Subject: Request for Revision of National Pollutant Discharge Elimination System
(NPDES) Permit No. IL0005037

Subject: Request for Revision of Quad Cities Station NPDES Permit
NPDES Permit No. IL0005037

**REVISED TEMPERATURE MONITORING CURVE FOR
QUAD CITIES NUCLEAR GENERATING STATION**

Figure 2. Revised Temperature Monitoring Curve.

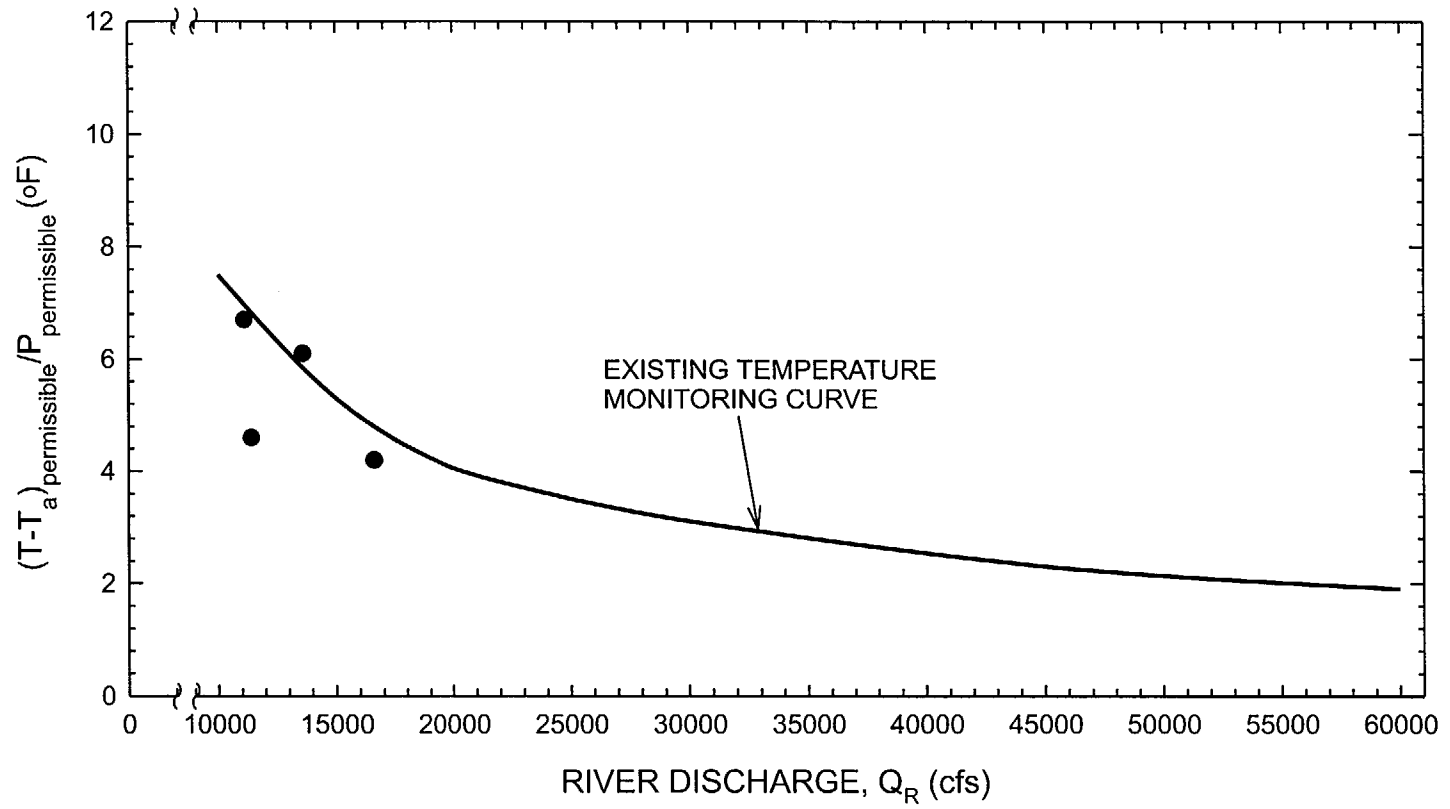
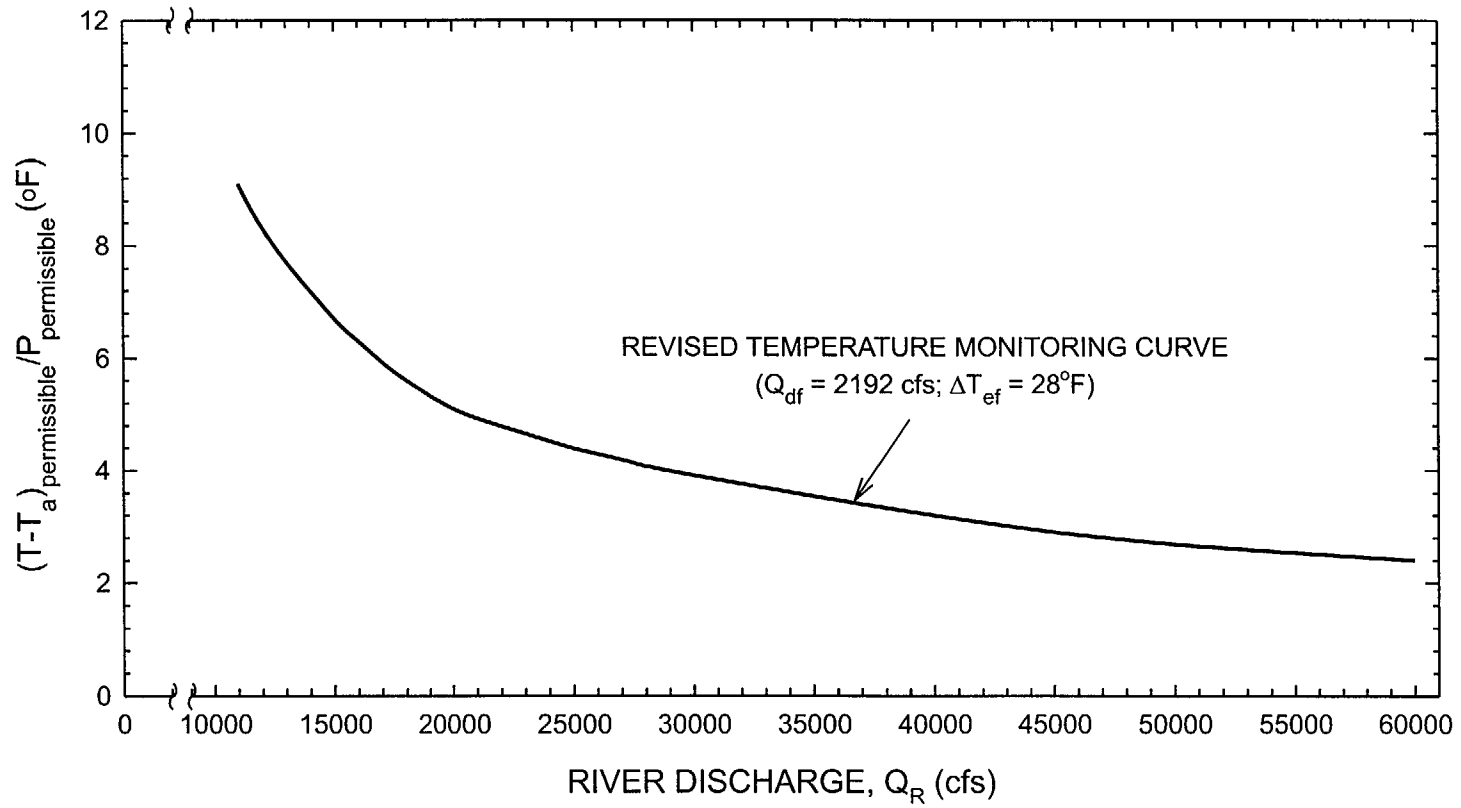
In connection with the EPU project, Exelon retained Dr. Subhash C. Jain to revise the temperature monitoring curve to reflect an increase in the discharge temperature of 5.0°F. Dr. Jain was one of the principle investigators responsible for conducting the 1990 study

that established the temperature monitoring curve referenced in the current permit. The report "Revised Temperature Monitoring Curve for Quad Cities Nuclear Generating Station" is enclosed for your review. The revised temperature monitoring curve indicates that at river flows of 21,100 cfs and greater, sufficient mixing is observed in the river to conclude that at any power level, the plant will not cause exceedence of the permitted thermal limits. Exelon proposes the Agency revise the permit to reflect this value and change Footnote 1 to reflect the revised temperature monitoring curve.

The existing TMC can be modified for applicable to the revised maximum effluent discharge and excess temperature by multiplying its ordinates by the ratio $\alpha = 1.27$. The revised TMC is presented in Figure 2.

¹**The revised temperature monitoring curve identified as Figure 2 in the December 2000 "Revised Temperature Monitoring Curve for Quad Cities Nuclear Generating Station."**
